Access Compliance Report Public Rights-of-Way (Curb Ramps)

Main Street: RYCROFT_RD		Cross Street: LA_LOMA_DR		Location:	NW
ADA ID: RPRK211012133859	Ramp Type:Type 1 - Perpendicular Diagonal Initial Pass/Fail: Fail		Overall Compliance: No	Severity Score:	16

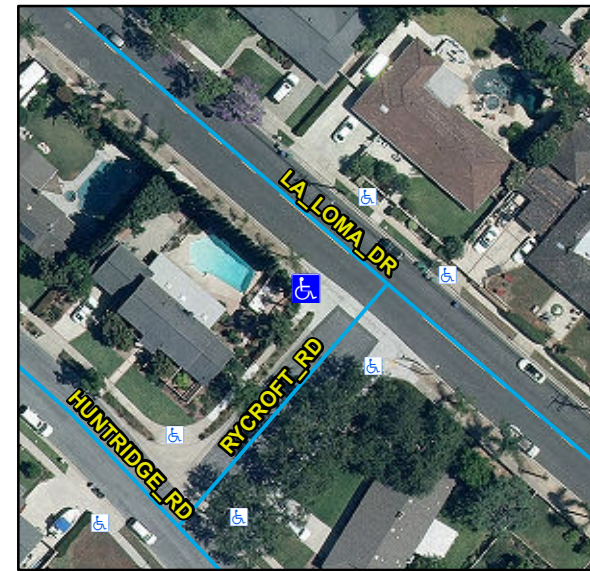
Compliance	Description	Data	Compliance	Description	Data
N/A	Ramp Length (in)	107	N/A	Flare Type LT	
Yes	Ramp Width (in)	48			N/A
No	Ramp Run Slope (%)	11.8	N/A	Flare Slope LT (%)	N/A
Yes	Ramp Cross Slope (%)	1.6	N/A	Flare Traversable LT	N/A
N/A	Landing Present	N/A	N/A	Flare Type RT	
N/A	Landing Length (in)	N/A			N/A
N/A	Landing Width (in)	N/A	N/A	Flare Slope RT (%)	N/A
N/A	Landing Run Slope (%)	N/A	N/A	Flare Traversable RT	N/A
N/A	Landing Cross Slope (%)	N/A	N/A	DWS Provided	N/A
N/A	Landing Movement Obstructed?	N/A	N/A	DWS Contrast	N/A
	Landing Movement Type	N/A	N/A	DWS Length (in)	N/A
N/A	Landing Shared	N/A	N/A	DWS Full Width	N/A
N/A	Clear Space	Yes	N/A	DWS Offset Left (in)	N/A
N/A	Clear Space To Crosswalk (in)	N/A	N/A	DWS Offset Right (in)	N/A
N/A	Marked Crosswalk 1	No	N/A	Marked Crosswalk 2	No
	Crossing 1 Direction	SE		Crossing 2 Direction	NE
	Marked Crosswalk 1 Width (in)	N/A		Marked Crosswalk 2 Width (in)	N/A

N/A	Ramp Inside Crosswalk 1	N/A	Yes	Ramp Inside Crosswalk 2	N/A
	Crossing 1 Slope (%)	4.3		Crossing 2 Slope (%)	6.2
	Crossing 1 Cross Slope (%)	2.1		Crossing 2 Cross Slope (%)	0.3
N/A	Gutter Ponding	N/A	No	Curb Slope	10
Yes	Gutter Lip Height (in)	0		Road Run Slope (%)	1.2
N/A	Gutter Run Slope (%)	N/A		Road Cross Slope (%)	1
N/A	Gutter Cross Slope (%)	N/A			
Yes	Overall Surface Condition: Acceptable		No	Perp Joint Present	No
	Cross Gutter Present?	Yes		Spandrel Present?	Yes
	Replace Cross Gutter?	No		Replace Spandrel?	No

Possible Solutions:

Remove & Replace Curb Ramp With Two New Directional Ramps or Equivalent.

R304.2.2, R204.3, STD 1115
